**FINAL
REMEDIAL ACTION WORK PLAN**

**REMEDICATION OF SOILS
AT LOAD LINES 1, 2, 3 AND 4
RAVENNA ARMY AMMUNITION PLANT
RAVENNA, OHIO**

CONTRACT NO. DACA45-03-D-0026
TASK ORDER 0001

| Appendix F Comment Response Table |

Figure 3-1
Haul Route Traffic Plan

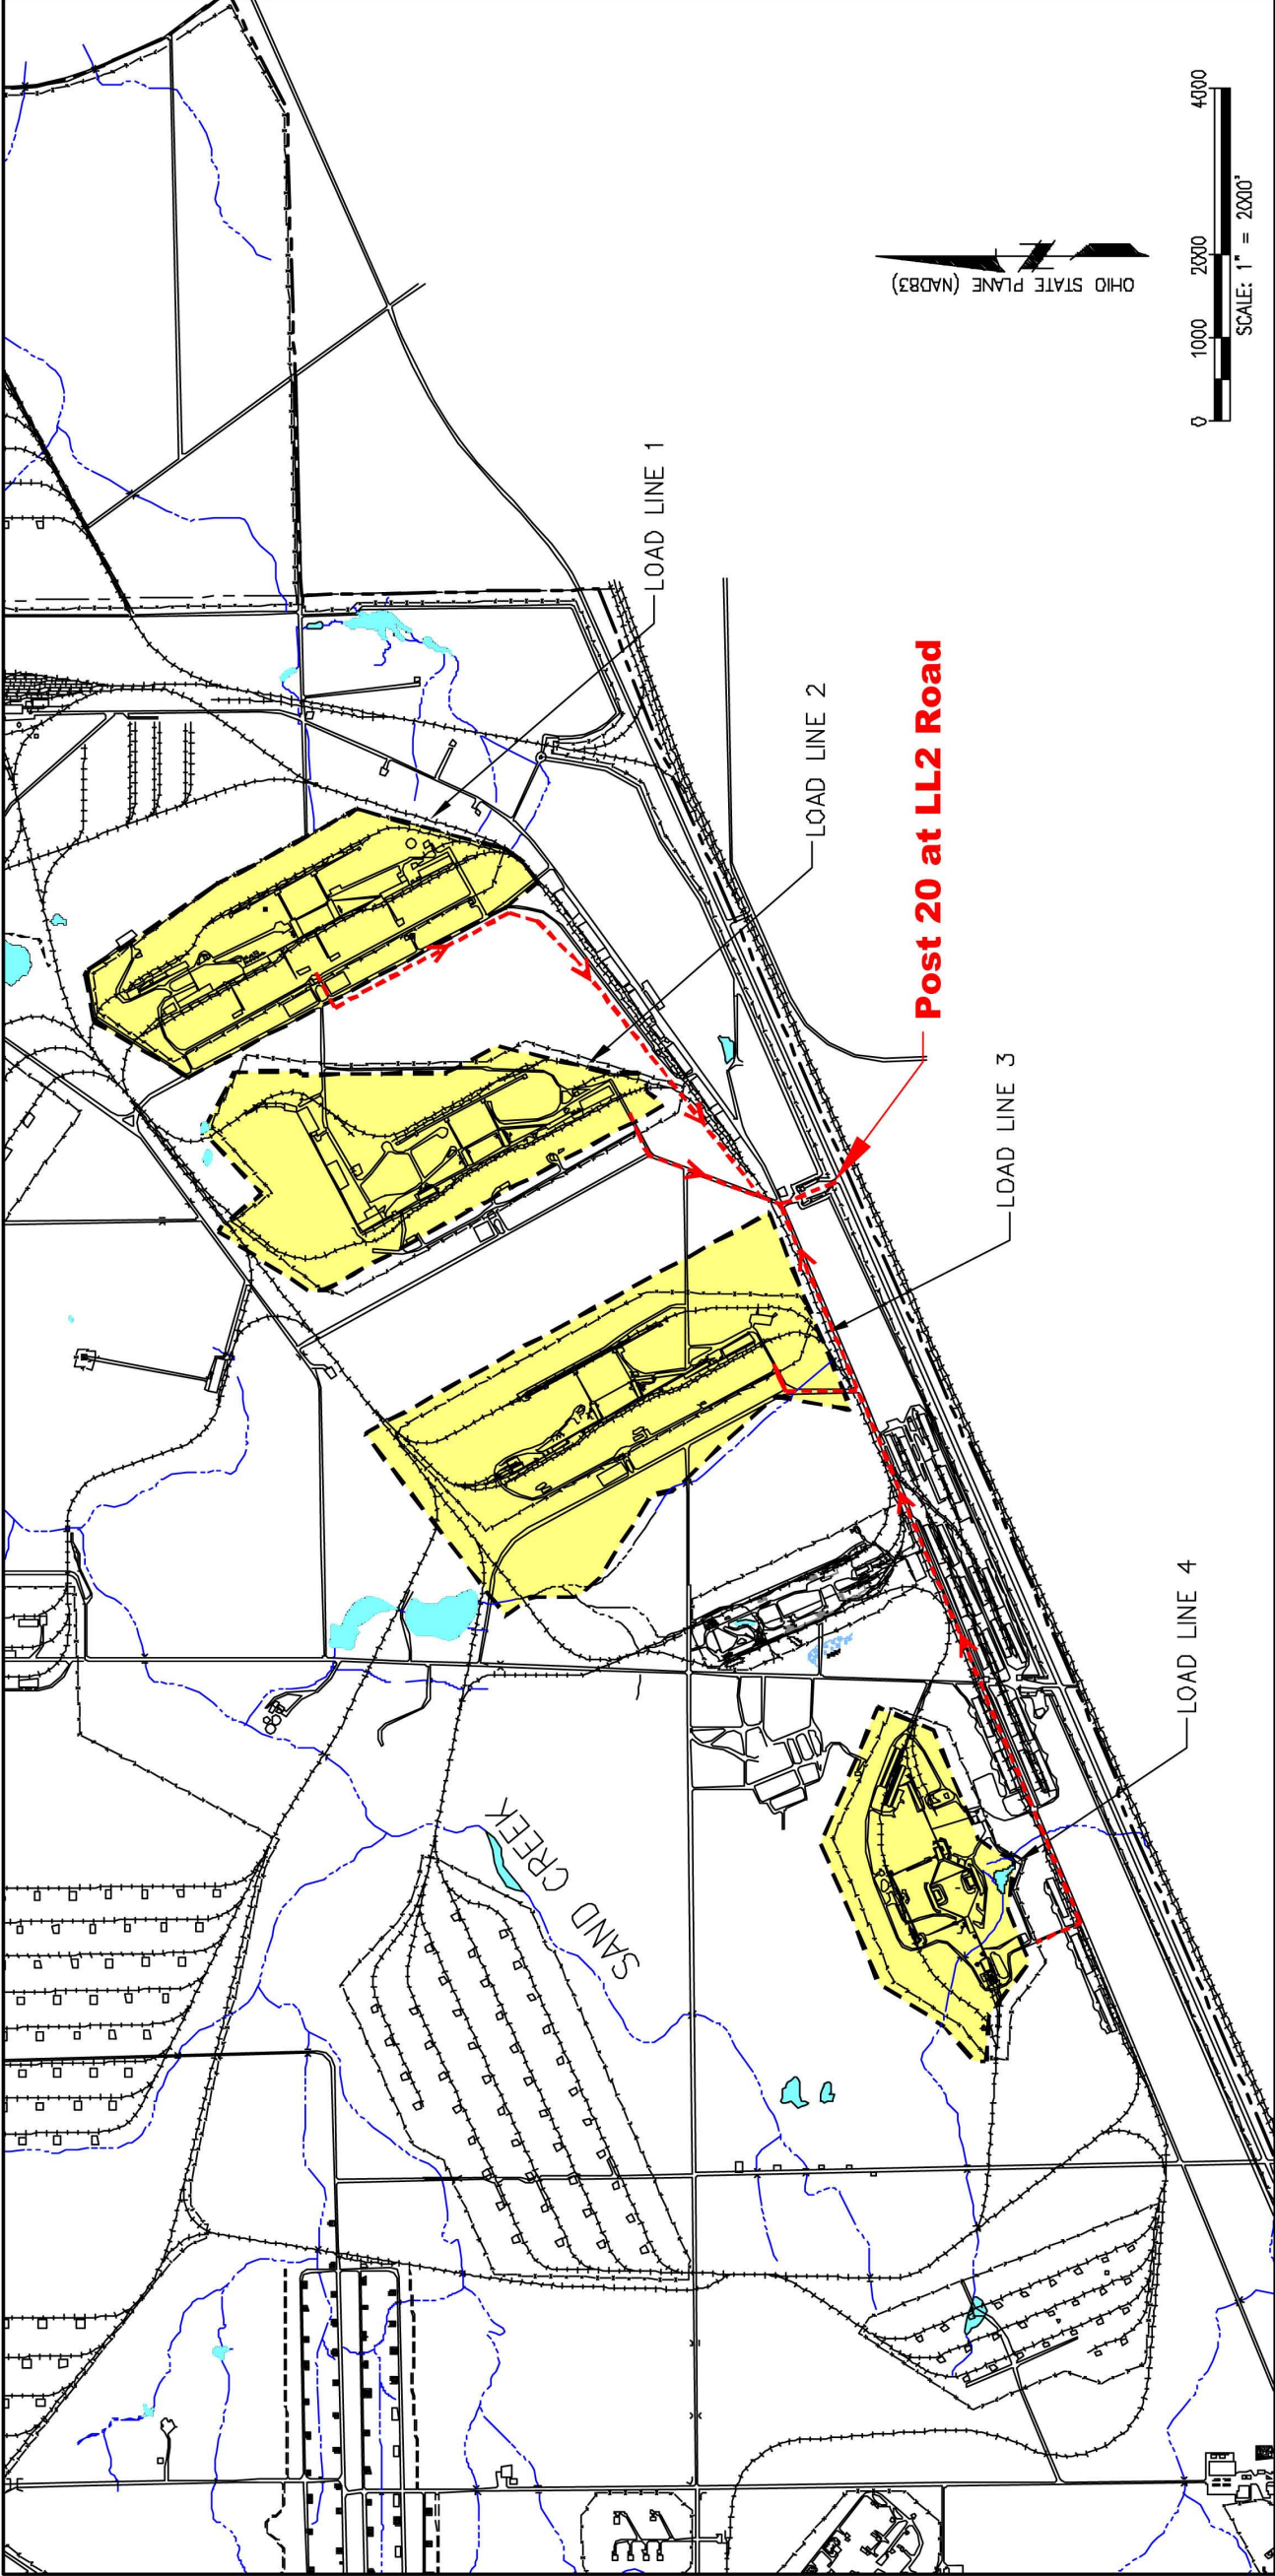
| Cmt.# | Page # Line # | Comment | Recommendation | Response |
|-------|------------------|--------------------------|--|---|
| 22 | Fig 3-1 | Confirmation requested. | Please confirm that truck traffic will be entering and exiting through this gate and not Post 1 at George Road. | Shaw proposes to utilize the Post 20 gate on LL2 Road for truck traffic and is currently coordinating with the RVAAP contracting manager, MKM, for staffing requirements. Figure 3-1 will be revised to correctly identify the gate as Post 20. |

| Cmt.# | Page # Line # | Comment | Recommendation | Response |
|-------|--------------------------|---|----------------|--|
| 78 | Fig 3-1 | Please label the gate or post number. | | The "South Service Road Access/Exit" on Figure 3-1 will be revised to "Post 20 Gate" |
